TENDER 7119-KP-21 - Addendum #4

Project: Elmira District S.S. - Window, Roof, HVAC & Sanitary Upgrades

Project Name:	Elmira District Secondary School – Window, Roof, HVAC and Sanitary Upgrades	Date Issued:	March 25, 2021
Quasar Project #:	ED-20-300		
Client Project #:	20931		
Addendum #: M-1 Revision #: 0

Project Name:	Elmira District Secondary School – Window, Roof, HVAC and Sanitary Upgrades	Date Issued:	March 25, 2021
Quasar Project #:	ED-20-300		
Client Project #:	20931		
Addendum #: E-1 Revision #: 0

M-105

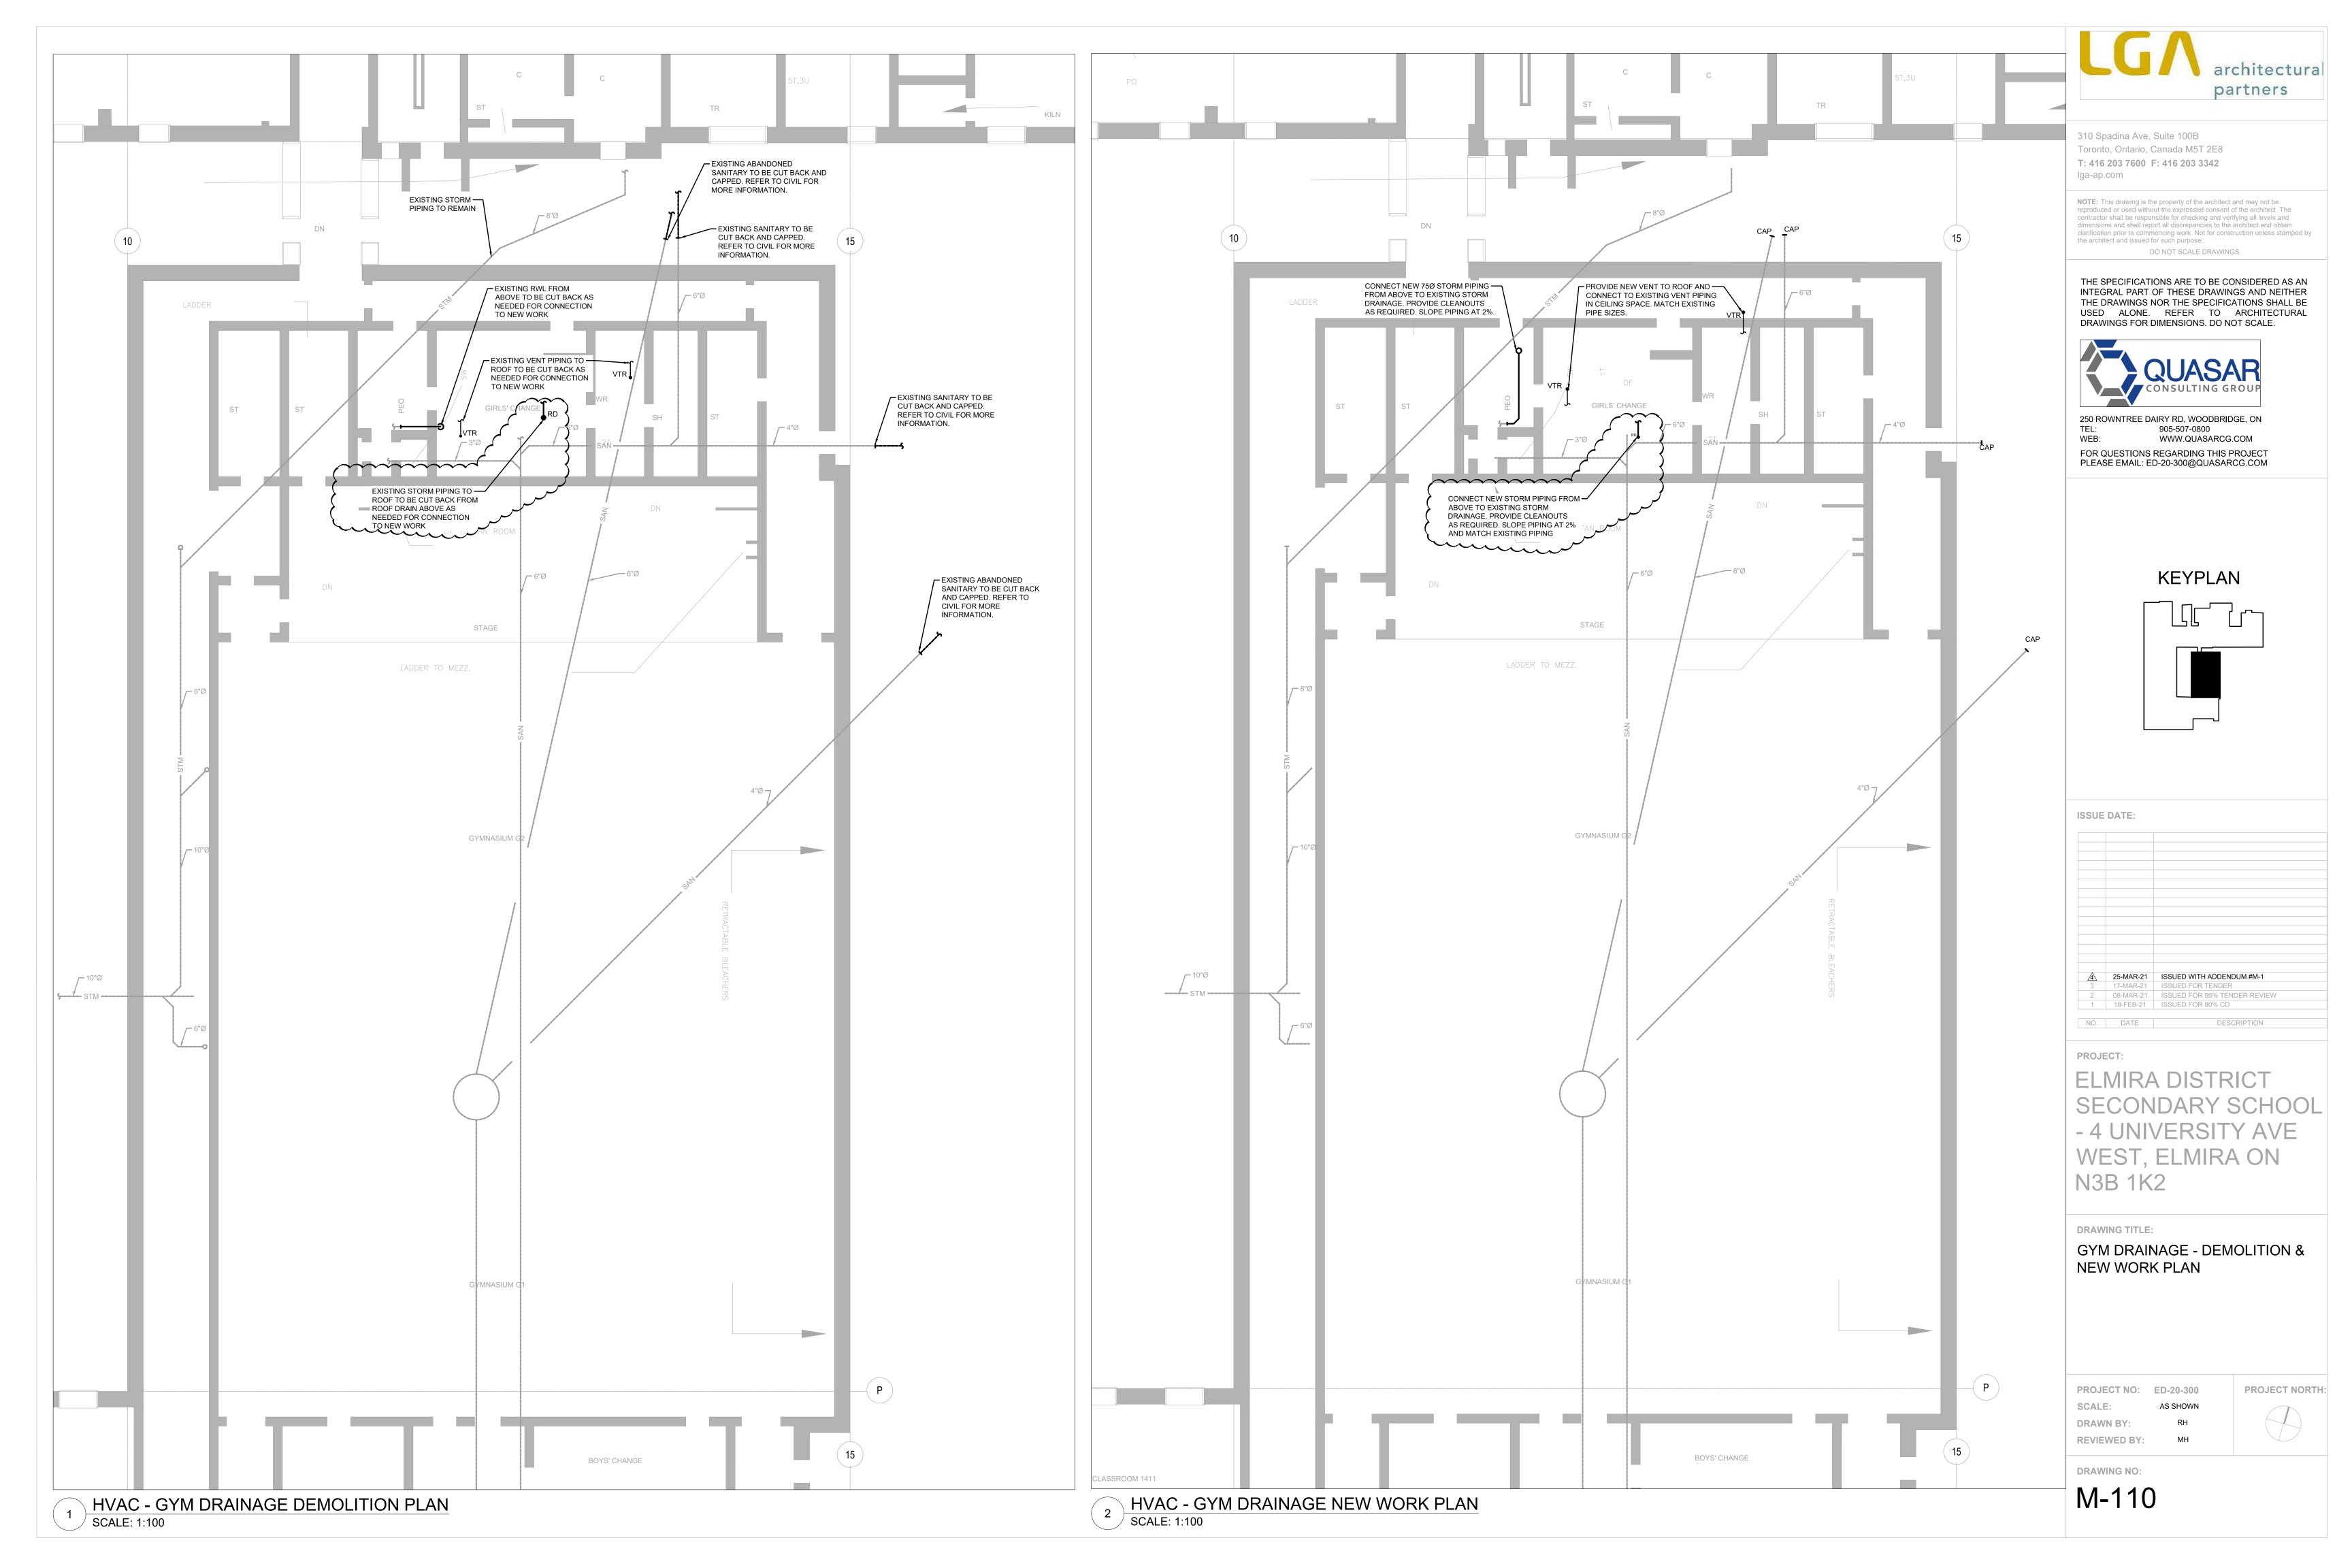
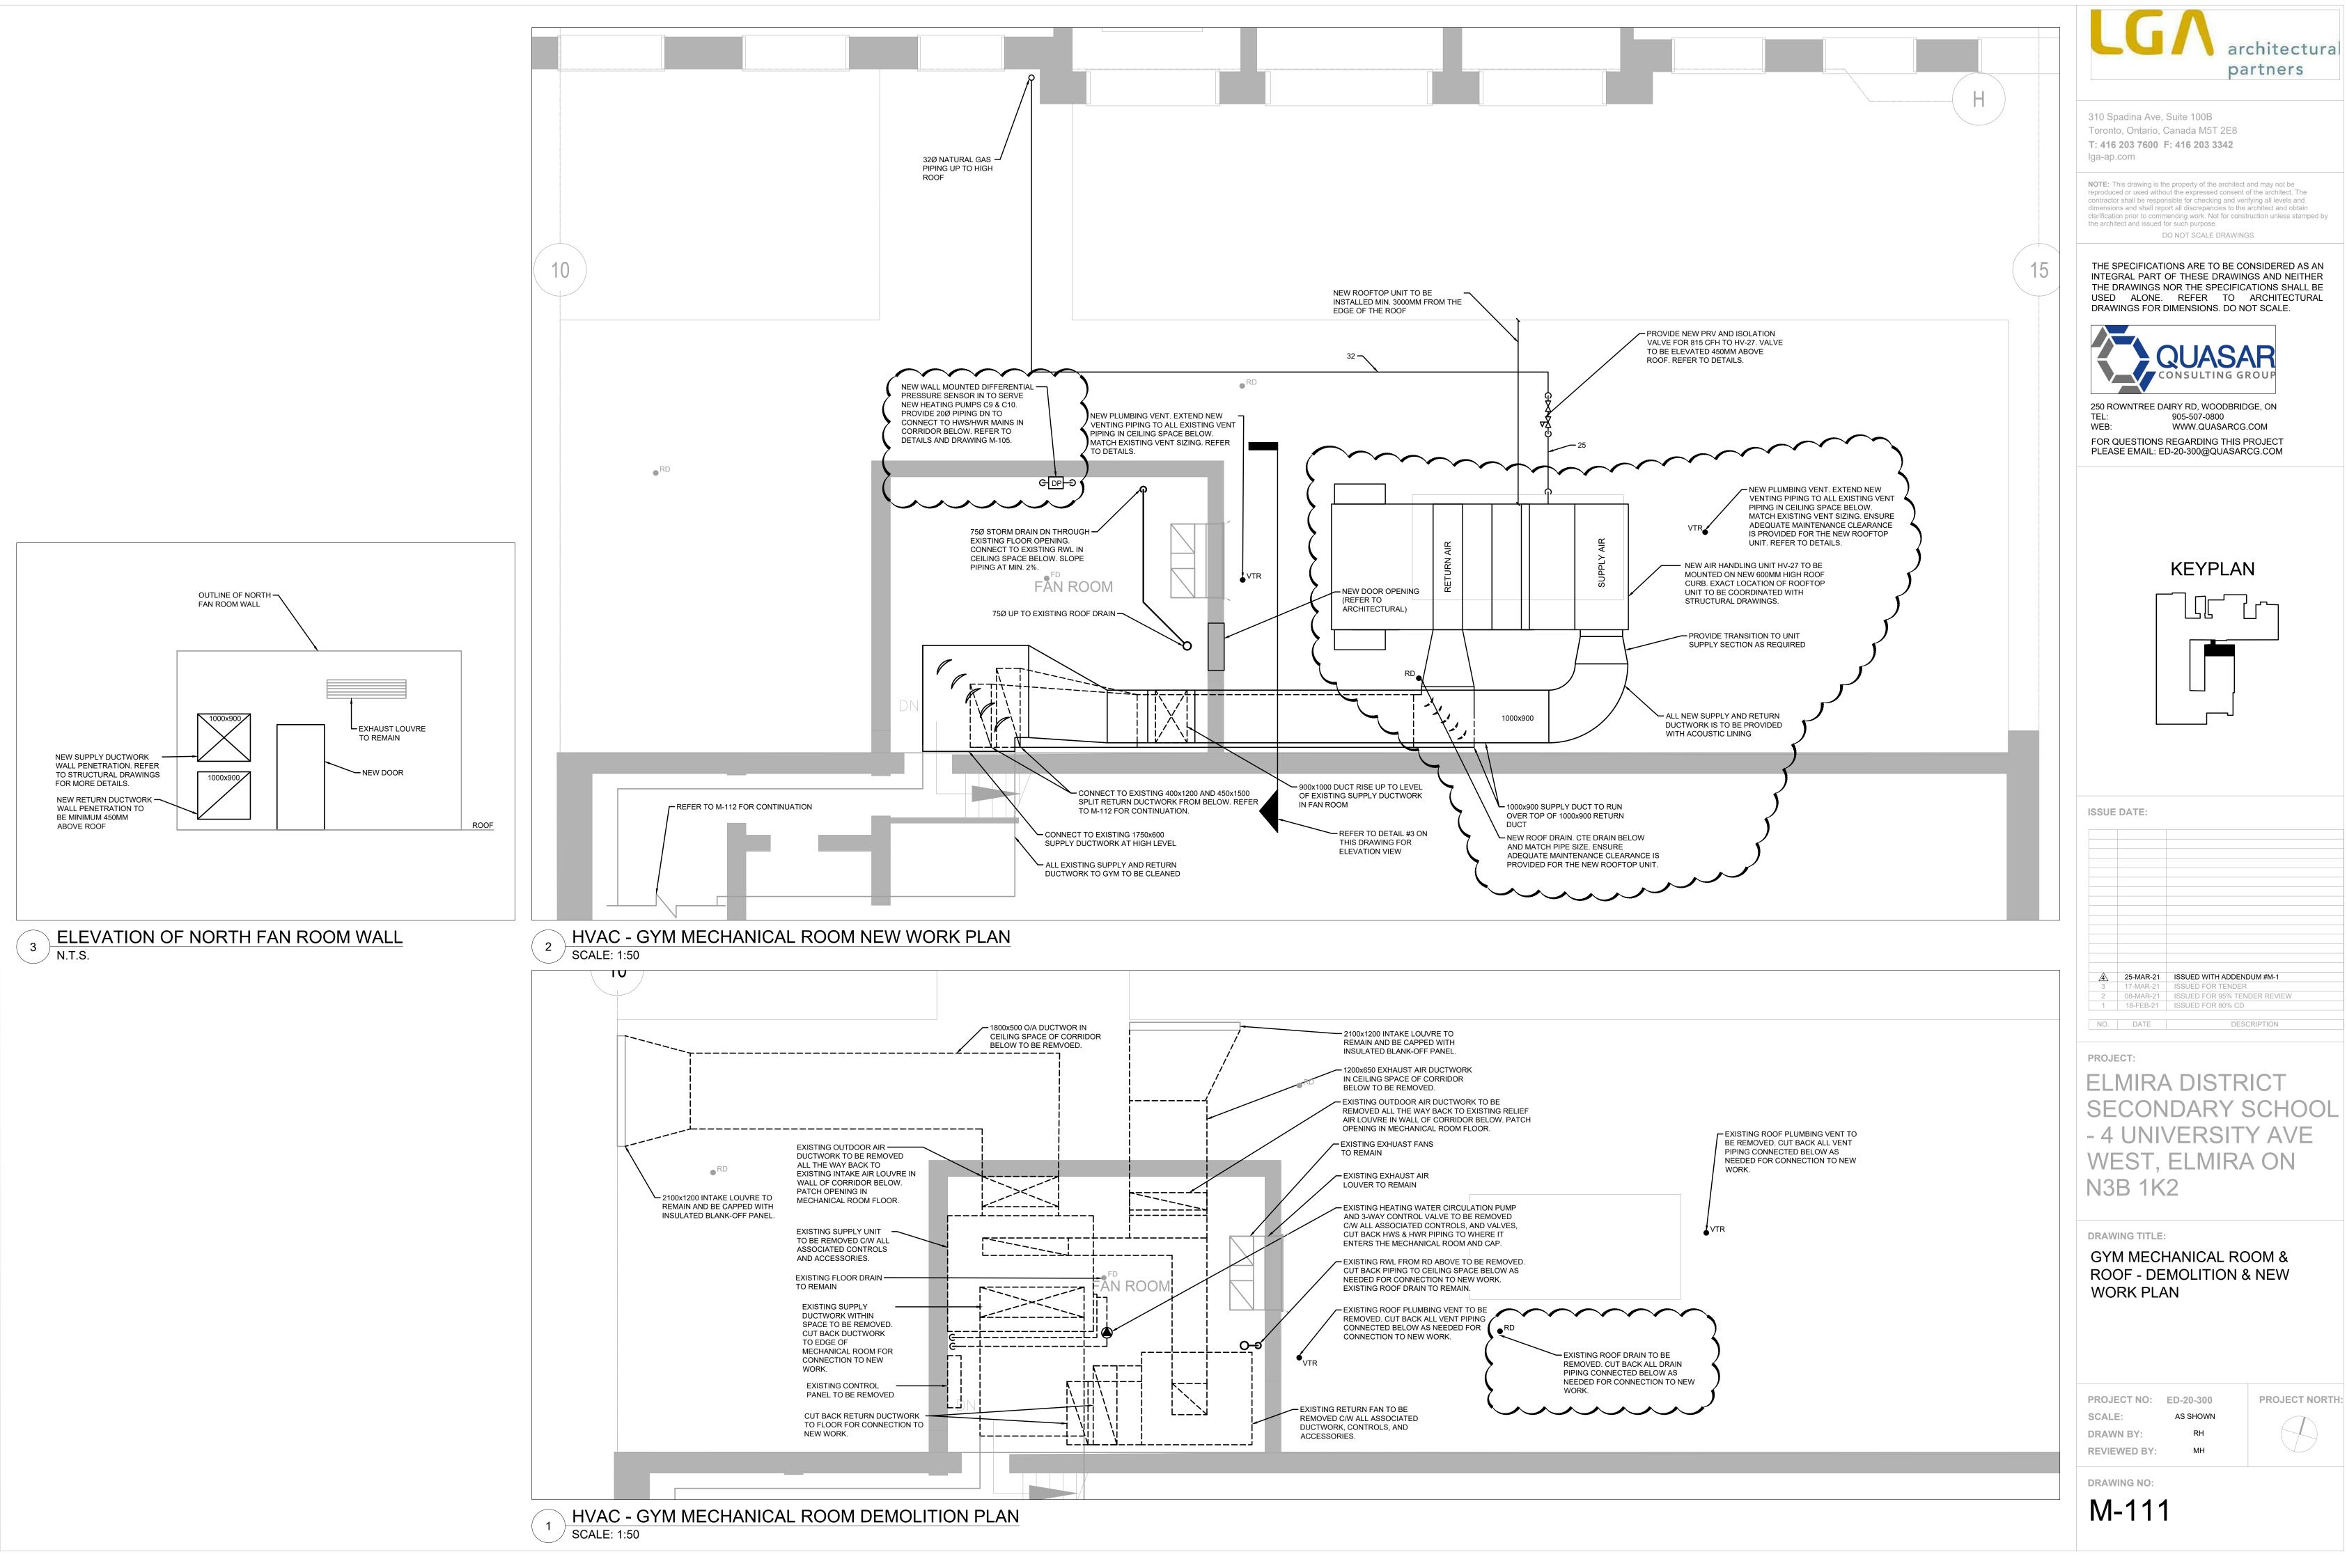
5. DRAWING M-105 – HVAC PIPING – GYM - DEMO AND NEW WORK PLAN

a. Addition of heating water piping to differential pressure sensor as shown.
